Access Compliance Report Public Rights-of-Way (Curb Ramps)

Main Street: TUDOR_WAY Cross Street: REGENT_PARK Location: SW

ADA ID: RPAT211103132619 Ramp Type: Type 4 - Parallel Initial Pass/Fail: Fail Overall Compliance: No Severity Score: 2

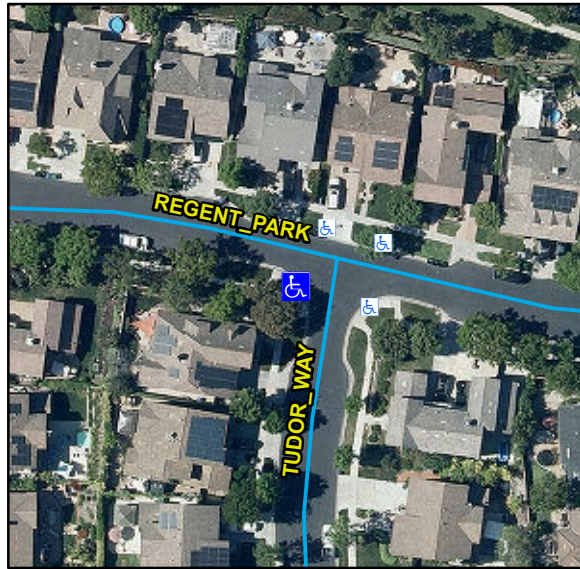
Compliance	Description	Data	Compliance	Description	Data
N/A	Ramp Length LT (in)	75	N/A	Ramp Length RT (in)	70
Yes	Ramp Width LT (in)	48	Yes	Ramp Width RT (in)	48
Yes	Ramp Run Slope LT (%)	5	Yes	Ramp Run Slope RT (%)	4.1
No	Ramp Cross Slope LT (%)	2.3	Yes	Ramp Cross Slope RT (%)	0.5
N/A	Landing Present	N/A	N/A	DWS Provided	N/A
N/A	Landing Length (in)	N/A	N/A	DWS Contrast	N/A
N/A	Landing Width (in)	N/A	N/A	DWS Length (in)	N/A
N/A	Landing Run Slope (%)	N/A	N/A	DWS Full Width	N/A
N/A	Landing Cross Slope (%)	N/A		DWS Offset Type	N/A
N/A	Landing Movement Obstructed?	N/A	N/A	DWS Offset Left (in)	N/A
	Landing Movement Type	N/A	N/A	DWS Offset Right (in)	N/A
N/A	Landing Shared	N/A			
N/A	Clear Space	Yes			
N/A	Clear Space To Crosswalk (in)	N/A			
N/A	Marked Crosswalk 1	No	N/A	Marked Crosswalk 2	No
	Crossing 1 Direction	SE		Crossing 2 Direction	NE
	Marked Crosswalk 1 Width (in)	N/A		Marked Crosswalk 2 Width (in)	N/A

N/A	Ramp Inside Crosswalk 1	N/A	N/A	Ramp Inside Crosswalk 2	N/A
	Crossing 1 Slope (%)	2.5		Crossing 2 Slope (%)	1.3
	Crossing 1 Cross Slope (%)	1.3		Crossing 2 Cross Slope (%)	1.5
N/A	Gutter Ponding	N/A	No	Curb Slope	11.2
Yes	Gutter Lip Height (in)	0		Road Run Slope (%)	0.6
N/A	Gutter Run Slope (%)	N/A		Road Cross Slope (%)	1.7
N/A	Gutter Cross Slope (%)	N/A	No	Perpendicular Joint Present	No
Yes	Overall Surface Condition	Acceptable			
	Cross Gutter Present?	No		Spandrel Present?	No
	Replace Cross Gutter?	N/A		Replace Spandrel?	N/A

Remove & Replace Curb Ramp With Two New Directional Ramps or Equivalent.
